Chapter 4. Changes

This chapter describes change from Code Generator for RL78 (CS+ for CA,CX) V2.10.00 to V2.11.00

4.1.5 Control correction of a competition pin

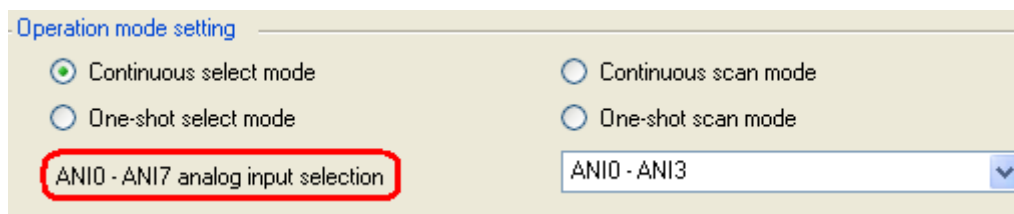
Control of the competition pin when simple-I2C of 24 and 25 pin device of RL78/G13 is set up was corrected.

Before : P17/SDA11
P30/SCL11

After : P50/SDA11
P30/SCL11

4.1.15 Additional function generation file mode

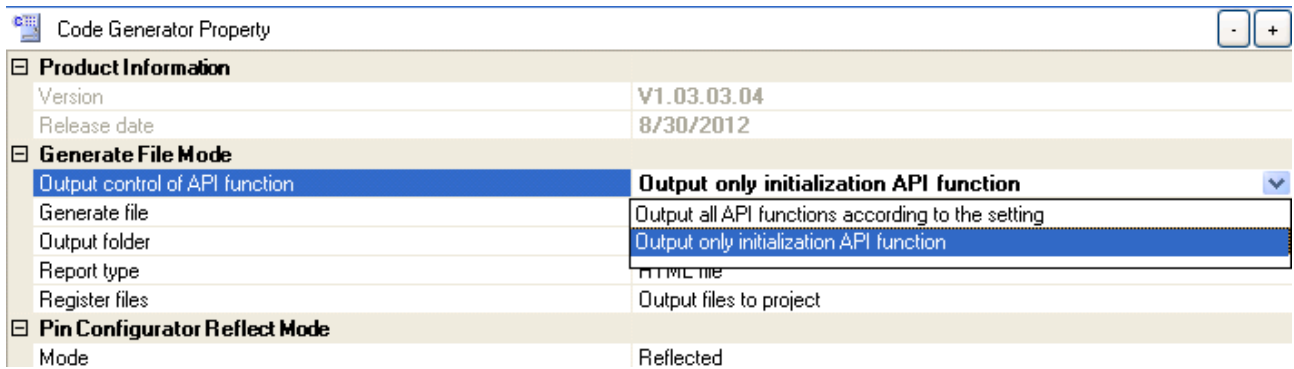
"Output control of API function" has been added to the Code Generator Property for RL78, 78K0R, and 78K0.

"Output all API functions according to the setting": Outputs necessary API functions according to the GUI settings (conventional output method).

"Output only initialization API function": Outputs only initialization functions (Create functions) regardless of the GUI settings.

4.1.18 Changes of input pulse interval measurement of TAU

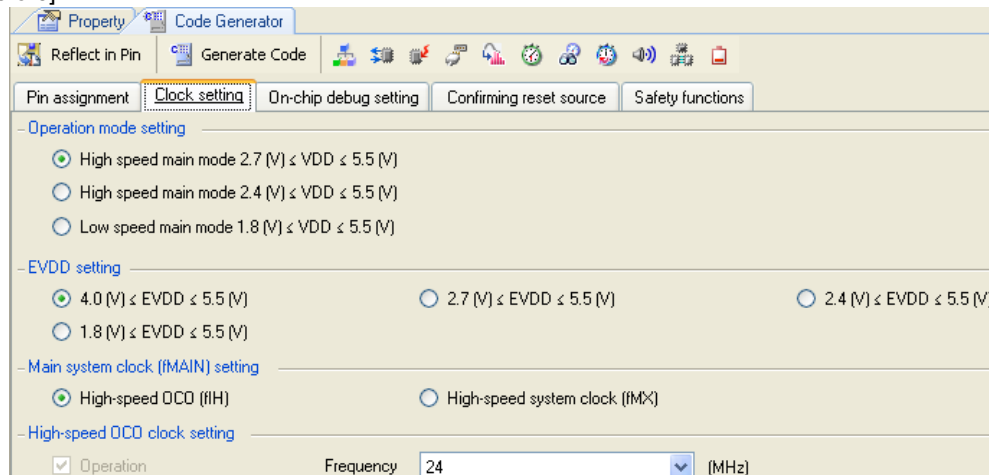
It corrected that the right measured value was not able to be acquired for the input pulse interval measurement function of TAU, and a high / low width measurement function by interruption function `r_taux_channelx_interrupt()` at the time of use.

This issue has been corrected in CubeSuite+ Code Generator for RL78,78K0R,78K0 V2.00.00.

4.1.19 Changes the notation of a power supply

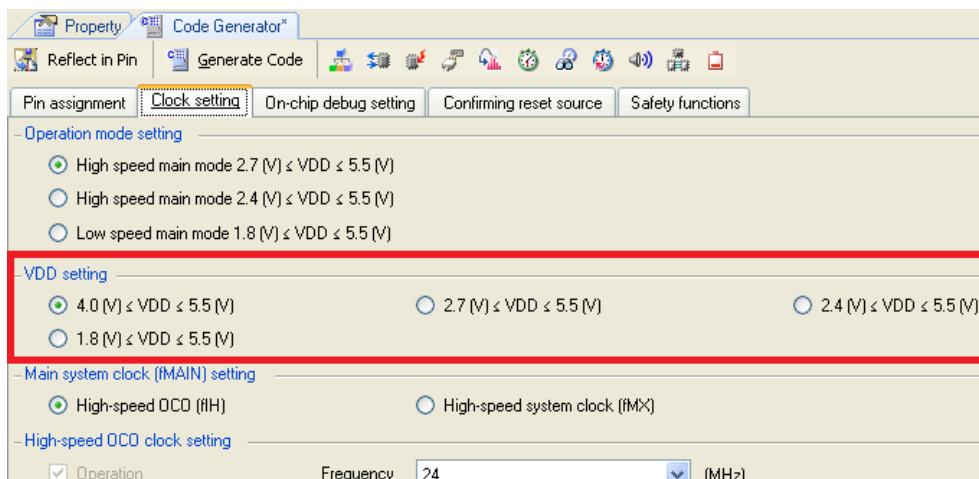
Although there was not EVDD in RL78/G12 device, it corrected that the notation remained on GUI.

This issue has been corrected in CubeSuite+ Code Generator for RL78,78K0R,78K0 V2.00.00.

5.2.8 Cautions of a setup of a real-time clock

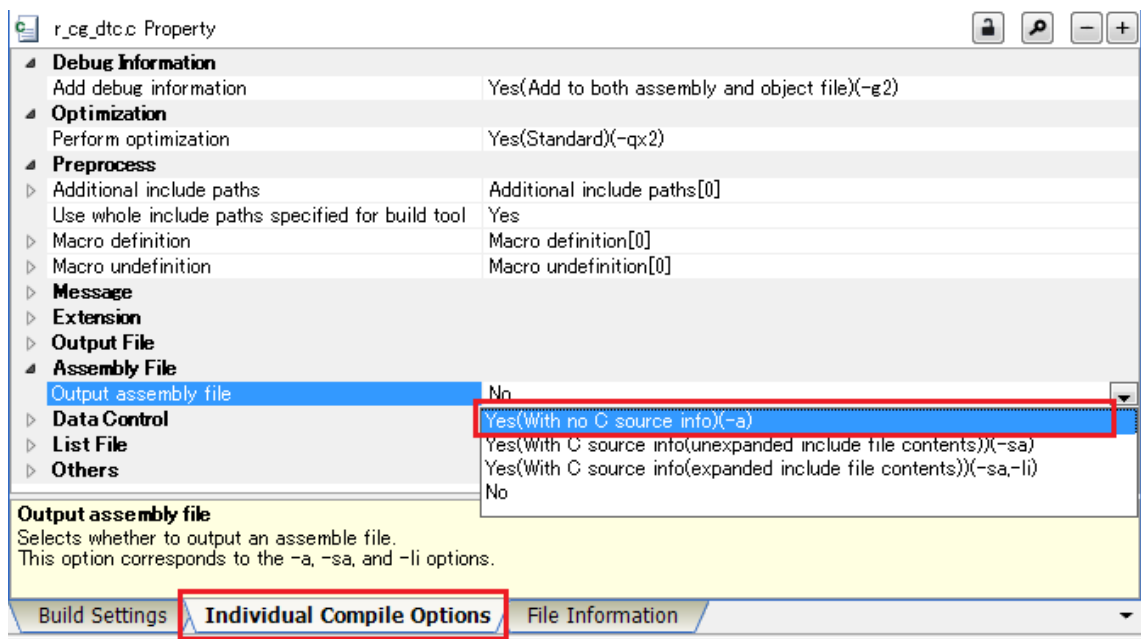
When a clock sauce is set to 15(fIL)kHz on device, clock function cannot be used. However, it is displayed on GUI that clock function seems to be used with 15(fIL)kHz. Please do not set up clock function.

[Workaround] CS+ RL78 Code Generator is corrected in V1.00.02.

5.2.15 Cautions of Safety Functions

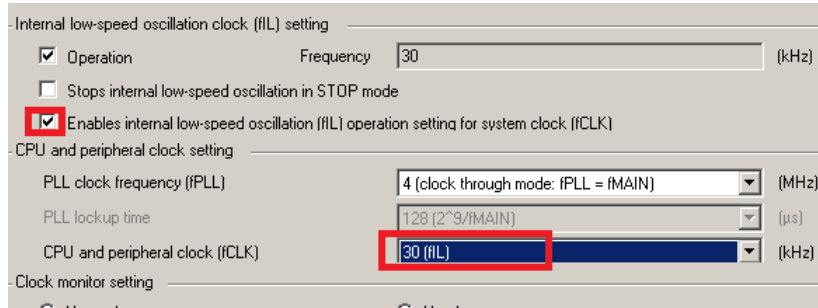
RAM parity error detection function of Safety Functions has not corresponded.

[Workaround] There is no workaround.

a) Clock

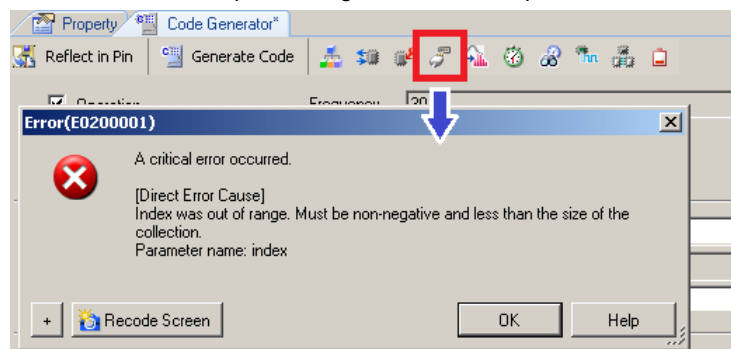
- Check in the two following items.

- Selection of a serial panel will generate an exception.

There is no workaround. CS+ RL78 Code Generator is corrected in V2.00.01

b) Timer and serial

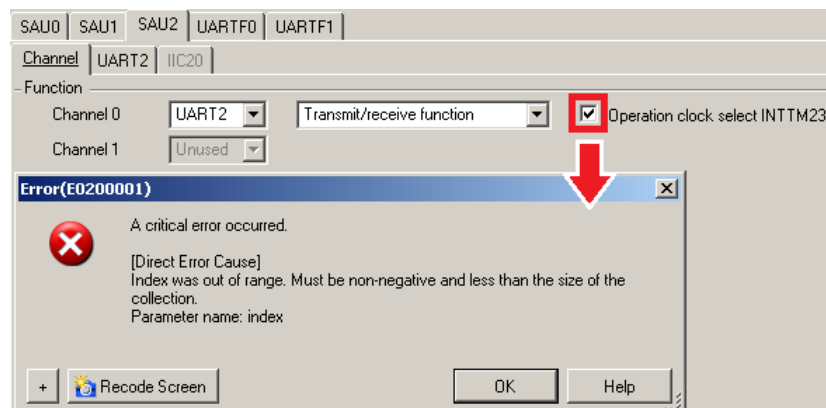
- Use interruption for the channel 3 of timer TAU2 in a certain mode.

- If a clock of operation checks one serial of serial SAU0, SAU1, and SAU2 "Operation clock select INTTM23", an exception will occur.

There is no workaround. CS+ RL78 Code Generator is corrected in V2.00.01

5.2.19 Cautions of a high-speed on-chip oscillator

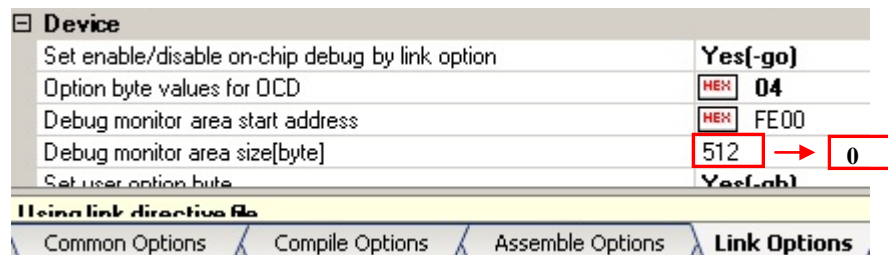
When a high-speed on-chip oscillator clock is set up by CubeSuite+ RL78, 78K0R, and 78K0 code generator V2.01.00 or earlier, If it is read by CubeSuite+V2.03.00, a clock frequency setup of a high-speed on-chip oscillator may not be right.

Please re-set up the frequency right in that case.

[Workaround] There is no workaround.
